Intersection ID: 10011423	Main Street: JEFF_ST	Cross Street: N/A	Location:	W
ADA ID: 118DA9CDEAA9	Ramp Type: Para	Initial Pass/Fail: Fail	Overall Compliance: No	Severity Score: 26.25

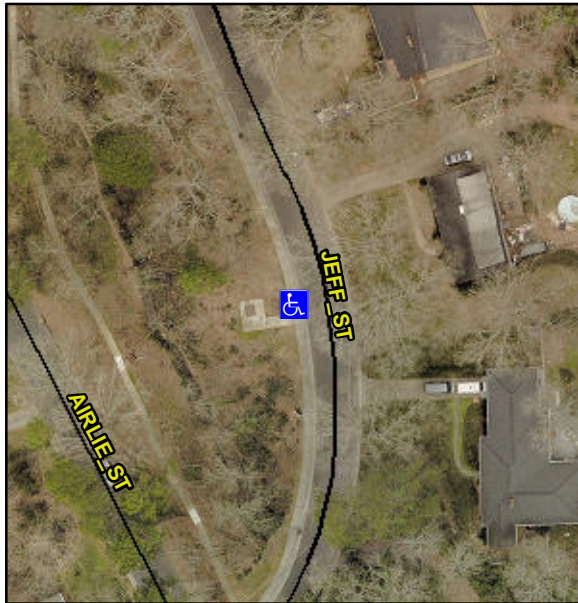
R304.5.3, R304.3.2

Compliance	Description	Data	Compliance	Description	Data
N/A	Ramp Length LT (in)	89.0	N/A	Ramp Length RT (in)	77.0
Yes	Ramp Width LT (in)	48.0	Yes	Ramp Width RT (in)	48.0
Yes	Ramp Slope LT (%)	5.5	No	Ramp Slope RT (%)	14.1
No	Ramp XSlope LT (%)	2.2	No	Ramp XSlope RT (%)	2.8
N/A	Landing Length (in)	N/A	N/A	DWS Provided?	N/A
N/A	Landing Width (in)	N/A	N/A	DWS Contrast?	N/A
N/A	Landing Slope (%)	N/A	N/A	DWS Length (in)	N/A
N/A	Landing X Slope (%)	N/A	N/A	DWS Full Width?	N/A
N/A	Landing Curb? (Y/N)	N/A	N/A	DWS Offset (in)	N/A
N/A	Shared Landing?	N/A			
N/A	Gutter Ponding?	N/A	N/A	Gutter Slope (%)	N/A
N/A	Gutter Lip Ht (in)	N/A	N/A	Gutter X Slope (%)	N/A
N/A	Painted X Walk1?	No	N/A	Painted X Walk2?	N/A
	X Walk 1 Direction	To E		X Walk 2 Direction	N/A
N/A	X Walk 1 Width (in)	N/A	N/A	X Walk 2 Width (in)	N/A
	X Walk 1 Slope (%)	3.0		X Walk 2 Slope (%)	N/A
	X Walk 1 X Slope (%)	3.3		X Walk 2 X Slope (%)	N/A
N/A	Ramp inside XWalk1?	N/A	N/A	Ramp inside XWalk2?	N/A

Remove & Replace Entire Ramp.
